**CITY OF VANCOUVER
DEVELOPMENT, BUILDINGS, & LICENSING**

**DEVELOPMENT PERMIT STAFF COMMITTEE
MEETING
November 24, 2021**

**327 Main Street (COMPLETE APPLICATION)
DP-2021-00788 – DEOD SUB-AREA 1 MAIN/HASTINGS**

Figure 5: Indigenous storytelling elements in the façade design

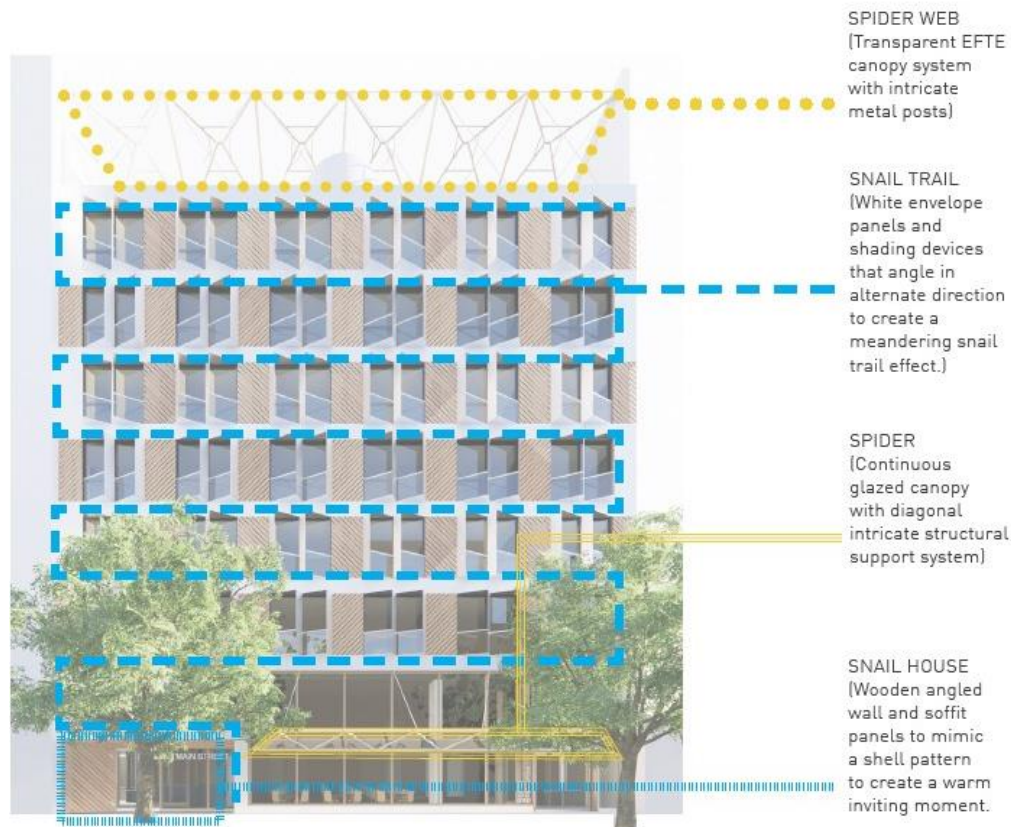
In response to the above-stated goal, the applicant proposes a façade that is more attentive to Indigenous narratives, as opposed to the *DTES Plan*, and *DEOD By-Laws and Design Guidelines* which

recommend building façades take on a tripartite composition (base, mid-shaft and top.) The proposed facade design draws upon indigenous storytelling highlighting the legend of “The Spider and the Snail”, which is a prominent featured design motif in the Indigenous basket weaving traditions. The concept envisions a building that proudly showcases the meandering trail and shell pattern; a long and winding road but yet a brave and beautiful one. The metaphor draws comparison to the recovery process of the residents in this “Transformation Lodge” (See Figure 5).
